**COMMUNITY DEVELOPMENT
DEPARTMENT REPORT**

HEARING DATE: 1/28/2025
TO: Mayor & City Council
FROM: Linda Ritter, Associate Planner
208-884-5533
lritter@meridiancity.org
APPLICANT: Ethan Mansfield, Hawkins Companies, LLC
SUBJECT: H-2024-0049
Fairview Drive-Through CUP, MDA
LOCATION: 4300 E. Fairview Avenue, located in a portion of the SW ¼ of the SE ¼, Section 4, T3N, R1E

D. Revised Site Plan (1/21/2025)

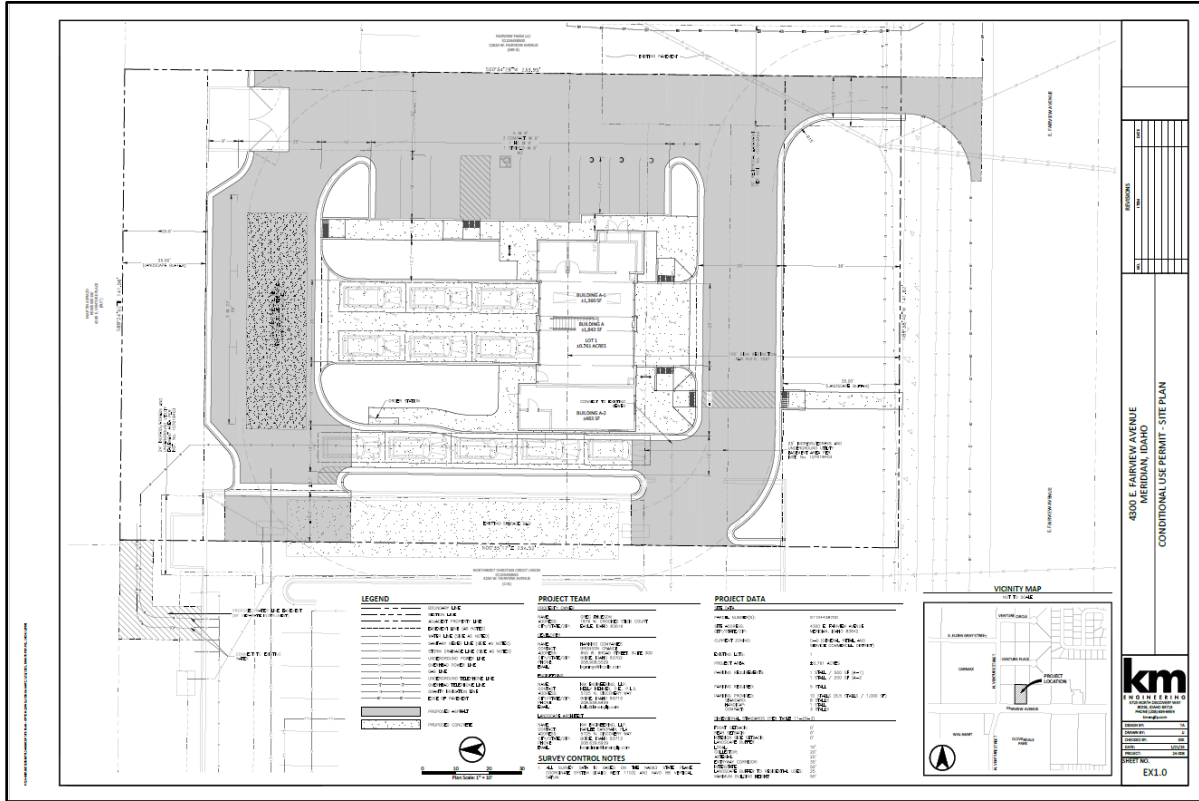
In reviewing the site plan, staff feels moving the employee parking to the south side of the lot to align with the parking layout for the adjacent bank to the west. Staff feels this will help minimize conflicts between vehicles using the coffee shop drive-through and customers accessing the quick-lube oil change facility, while also ensuring sufficient stacking space for the coffee shop drive-through.

In reviewing the site plan layout, staff recommends that employee parking be located on the south side of the lot to align with the parking layout for the adjacent bank to the west. This arrangement would help minimize conflicts between vehicles using the coffee shop drive-through and customers accessing the quick-lube oil change facility, while also ensuring sufficient stacking space for the coffee shop drive-through.

Fifteen (15) days prior to the City Council hearing, the applicant shall provide the revised concept plan for the site and landscaping plan showing the employee parking located on the south side of the lot to align with the parking layout for the adjacent bank to the west or a layout that is amenable to the staff and the applicant.

Site Plan (date: 10/28/2024)

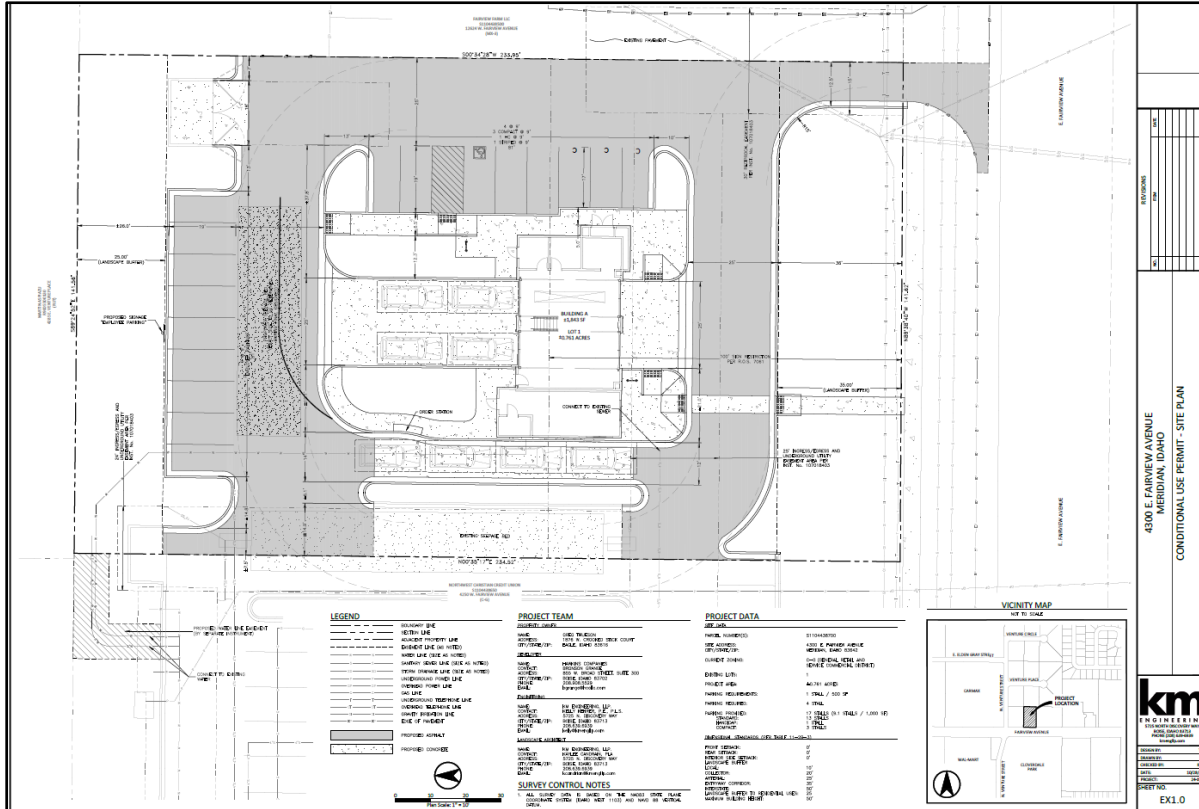
The applicant is requesting a Council waiver to place the trash enclosure into the landscape buffer to match the existing trash enclosure for the adjacent property to the west. Staff is asking the applicant to work with the adjacent property owner to expand the existing trash enclosure and request council waiver to reduce the landscape buffer for the area in which the trash enclosure is located.
